Technical Service Bulletin: tsb100179

New Crankshaft Thrust Bearing Design

This service parts/topic introduces changes to the QSK45 and QSK60 crankshaft thrust bearing design.

Fig. 1.

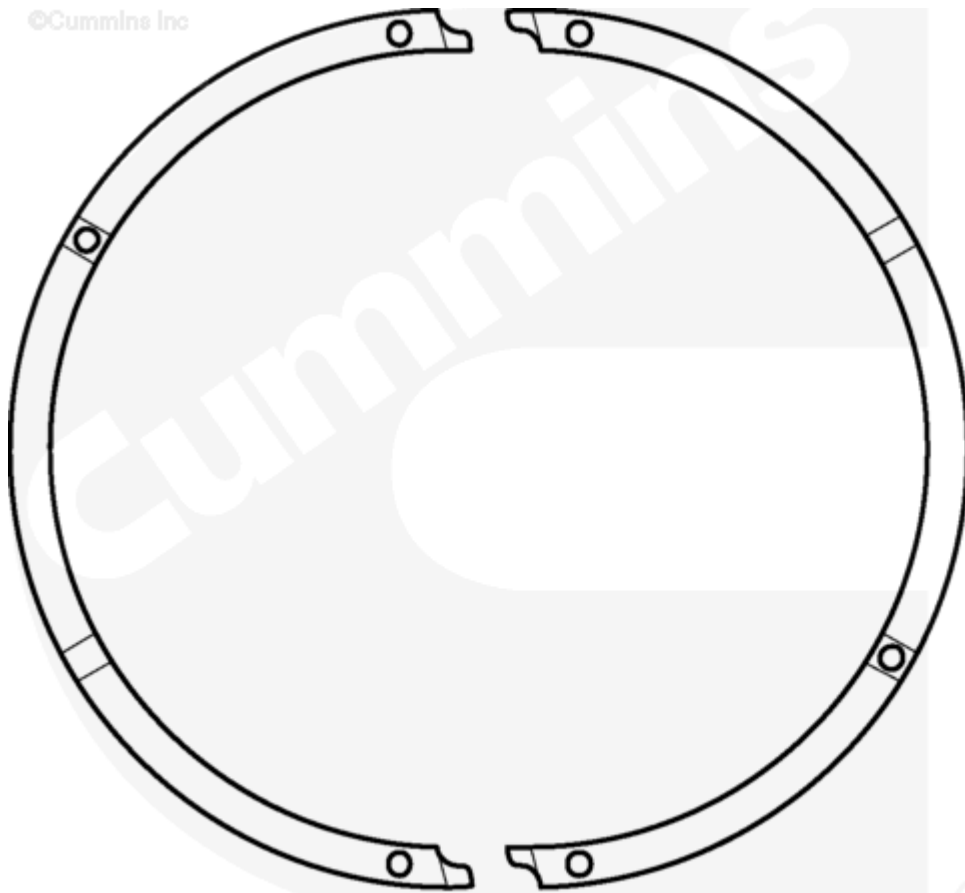
Changes have been made to the thrust bearing design to increase fatigue strength and also to fail-safe the thrust bearing from incorrect installation.

To improve the fatigue strength a different material has been used in conjunction with a change to the thrust bearing face geometry. To fail-safe the thrust bearing from incorrect installation a change has been made to the area of the thrust bearing that overlaps.

Figure 1 shows the two halves together, figure 2 shows the old design of thrust bearing in the overlap area. Figure 3 show the new design of thrust bearing in the overlap area.
